## Site Instruction #04

**Project:** Carleton Place Arena  
Neelin Street

**Date:** February 8, 2021

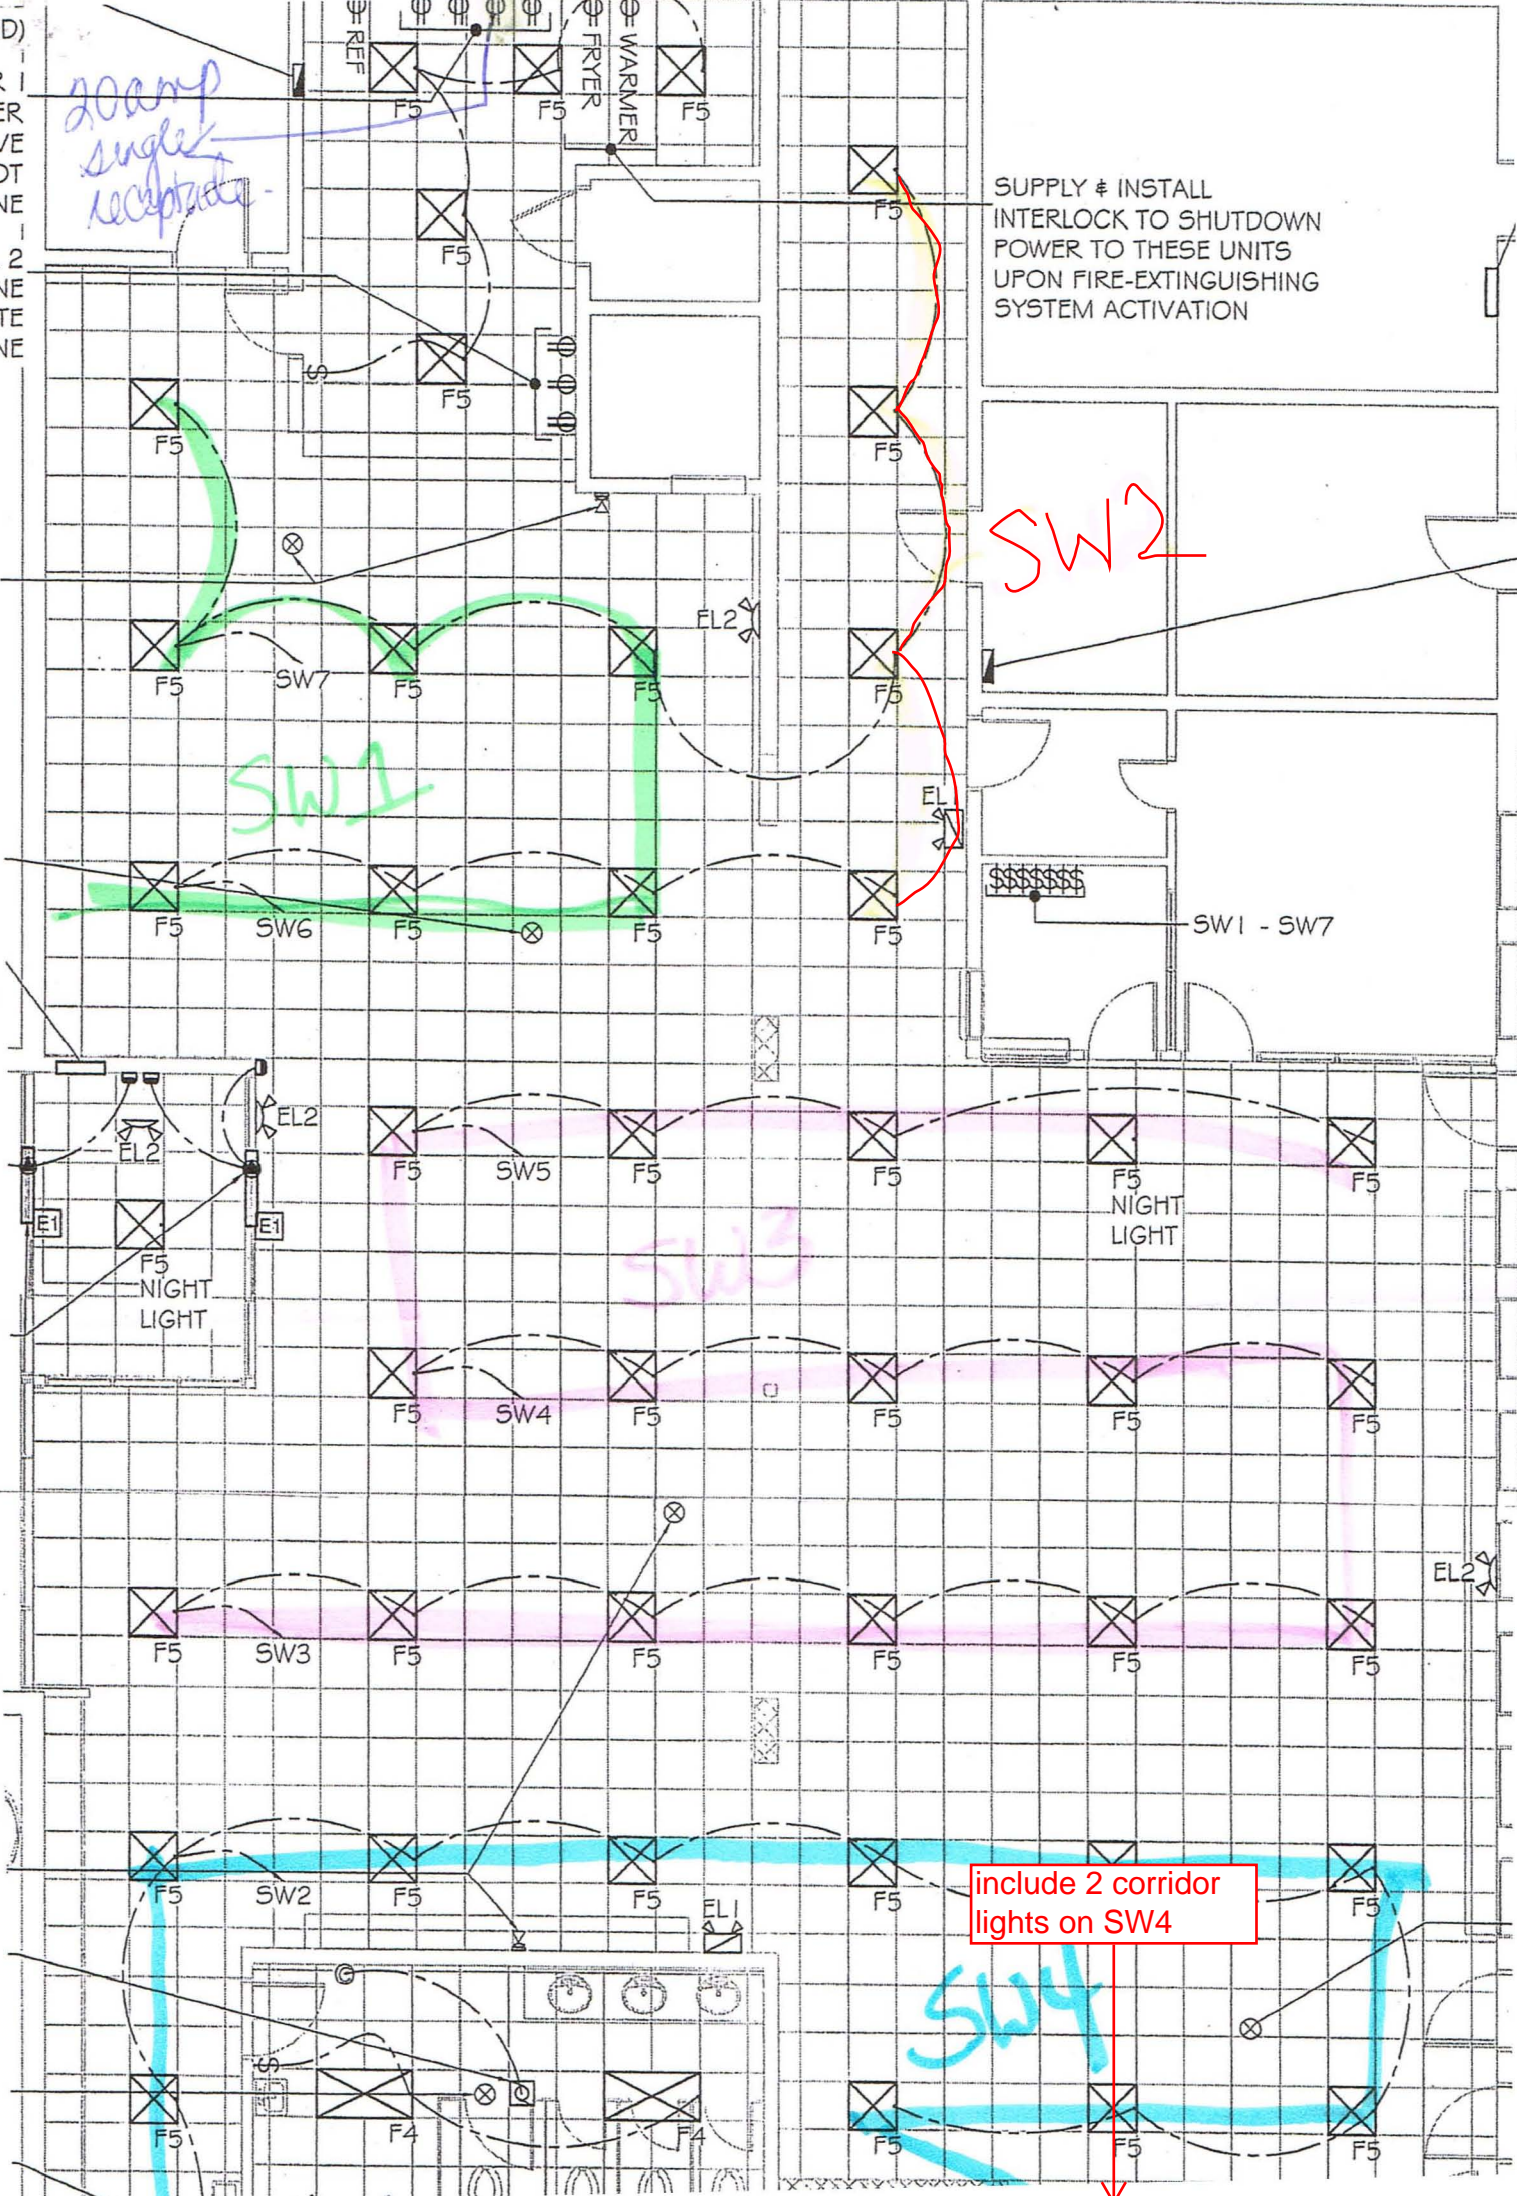
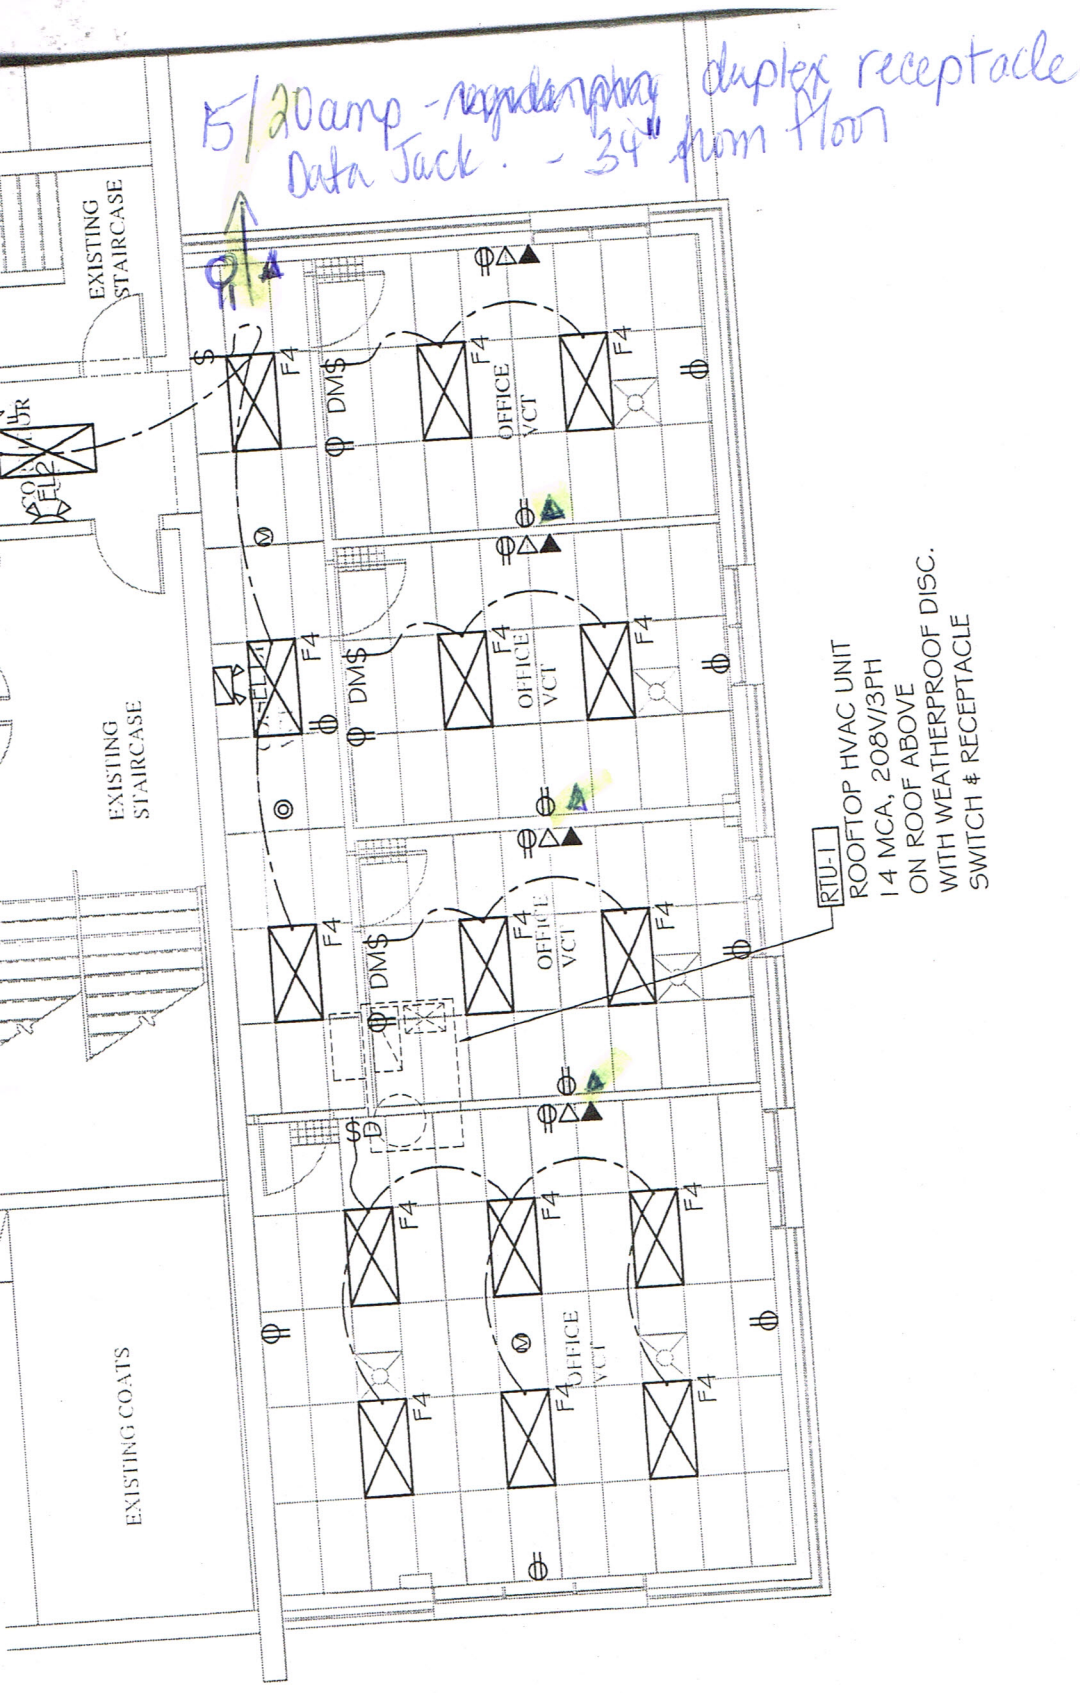
1. Revised Lobby light switching reducing 7 switches to 4 switches and adding receptacle in new kitchen
2. Add four data connections and one new receptacle

20amp  
single  
receptacle

SW2

SW1

SW1 - SW7

SW3

include 2 corridor  
lights on SW4

SW4
